PUBLIC MEETING AGENDA

MUNICIPALITY OF WOODSTOCK, VERMONT
WOODSTOCK CONSERVATION COMMISSION
31 The Green
Woodstock, VT 05091

A. T-0033-26 – Ana Cristina Arumi

B. T-0035-26 – Green Mountain Horse Association

**PH. 2 UPWEY ARENA
CROSS SECTIONS &
CONSTRUCTION
DETAILS**
C-4.2

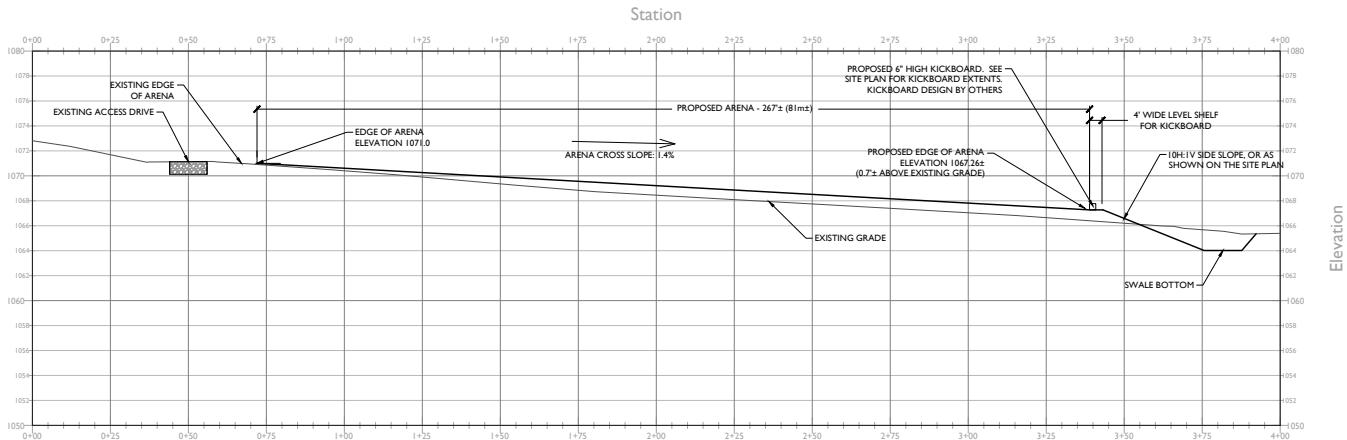
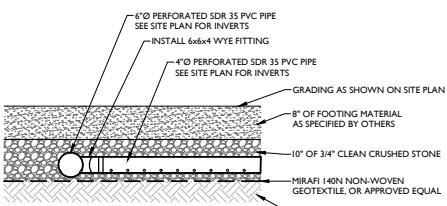
The arena is proposed to be raised slightly in elevation with installation of a kickboard to retain material in the arena. The proposed arena modifications restrict the available floodplain at the base flood discharge (1% annual chance/100 year flood) which causes the increase in WSE and velocities within the stream channel and along the stream bank opposite the arena. The concern is predominantly with the significant increase in velocities along the left bank (adjacent property – Tack Shop) which could cause increased erosion/loss of land and also exacerbate impacts and maintenance needs to the downstream bridge crossing at Morgan Hill Rd.

As a result of our initial Act 250 review, we have requested design changes to reduce the proposed increases in flood velocities so that the project meets the No Adverse Impact standard in the ANR's Procedure, as well as Woodstock's [local floodplain regulations](#). Following submission of the requested design revisions which are expected by 4/1 from the

Figure 1. Inundation of GMHA facility and Kedron Brook floodplain near Upwey arena and Morgan Hill Road under existing conditions in 100-year flood event.

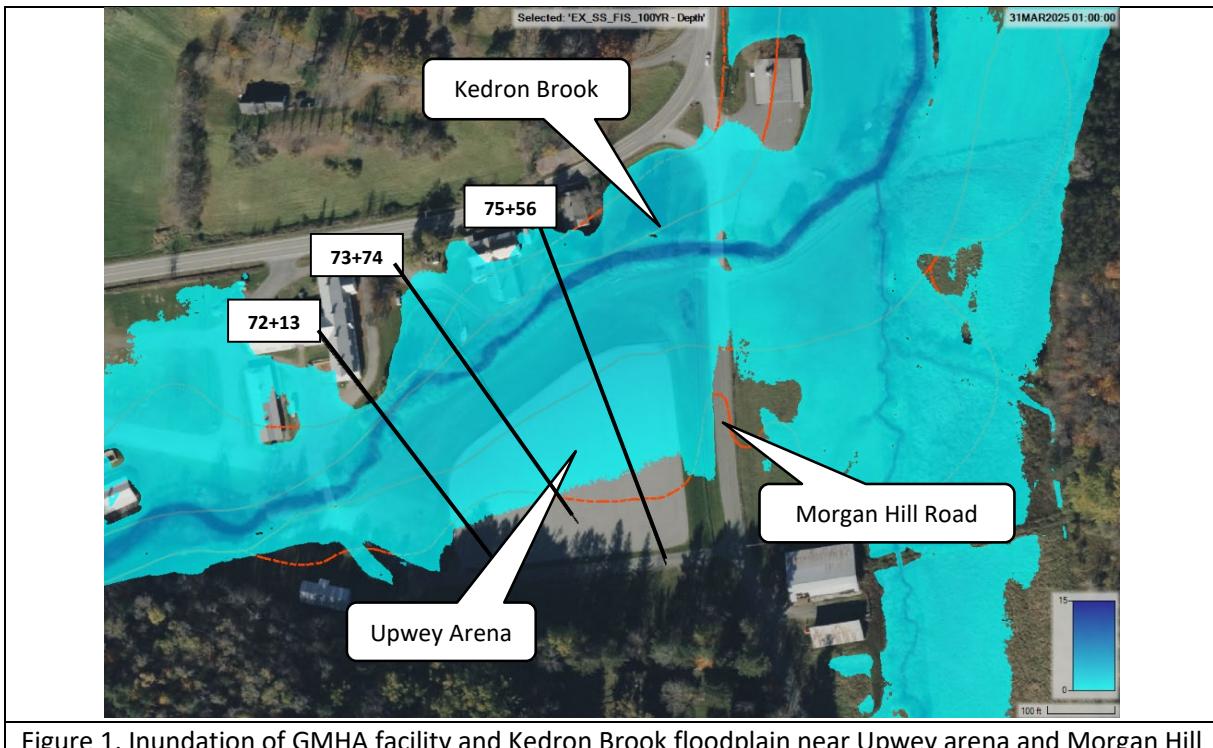
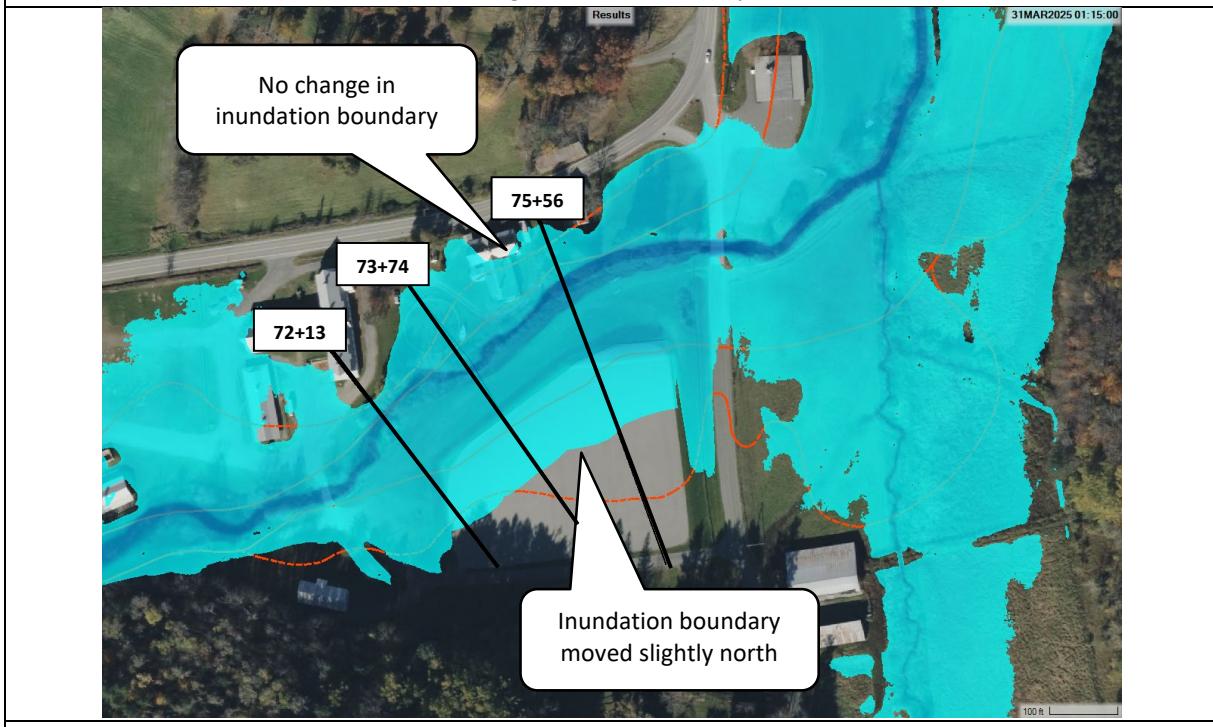
As proposed, the project includes changes within the SFHA and the Floodway of Kedron Brook. On Page 22 of the Woodstock Planning and Zoning Application, Table 3 of the 11/6/25 Memorandum from Fitzgerald Environmental identifies increases in flood velocities (+16% max) and water surface elevations (WSE) (+0.02' max) resulting from encroachments related to modification of the Upwey arena. From a regulatory perspective, it's especially important to limit adverse impacts due to the location within the FEMA Regulatory Floodway.
